PLANNING REVIEW CHECKLIST

Subject Property: 4650-4680 Hazelgreen Road NE

Ref#: 23-121805-PLN (Urban Growth Area Preliminary Declaration, Class 3 Site Plan Review, Class 2 Driveway Approach Permit, Class 2 Adjustment, Class 1 Adjustment, Class 1 Design Review, Property Line Adjustment)

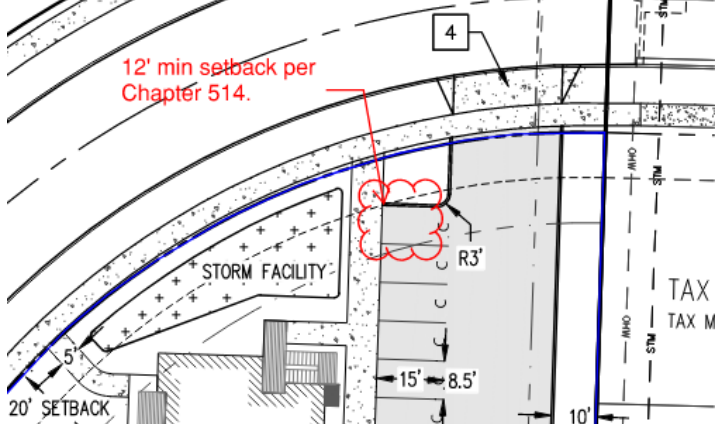
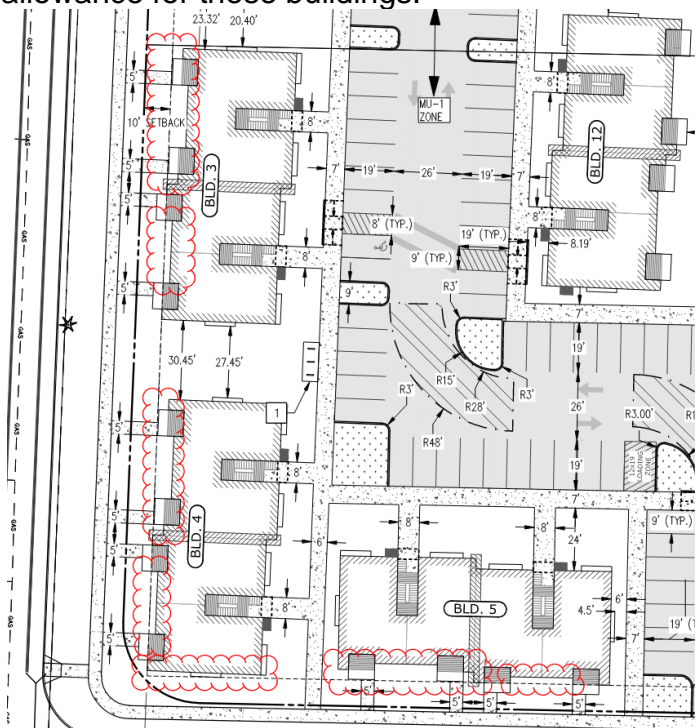
| Item: | |
|--|--|
| Class 2 Driveway Approach Permits (5) and Adjustments | <p>The applicant paid for two driveway approach permits where five new driveway approaches are shown on the plans. The applicant shall update their written statement and shall pay the applicable fee for all driveway approaches serving the new development.</p> <p>NOTE: If the applicant removes the 10-foot-wide approach, discussed below, only 4 driveway approach permits would be needed.</p> |

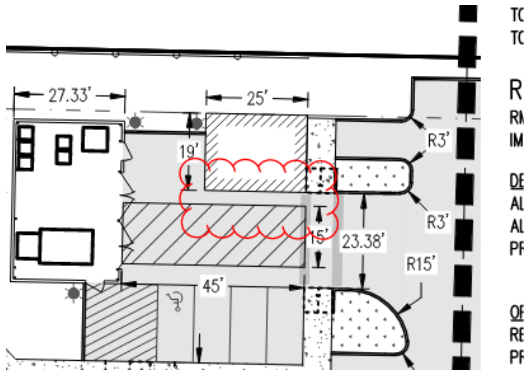
| Item: | |
|--|--|
| Driveway Approach Adjustments | <p>The applicant shows a 10-foot-wide approach serving a single building. It is unclear based on the information submitted what the use of this building is. SRC 806.035(f) restricts back-out parking into the street for commercial uses. It does not appear that adequate maneuvering space is provided on-site to ensure vehicles will not back-out into</p> |

| | <p>the street. In addition, the driveway approach does not meet minimum width standards in SRC 804.050(b)(2) for one-way or two-way traffic. The applicant should indicate whether or not they are requesting adjustments to these standards.</p> <p>Staff is not supportive of adjustments to SRC 806.035(f) and SRC 804.050(b)(2) for the proposed 10-foot-wide approach.</p>  |
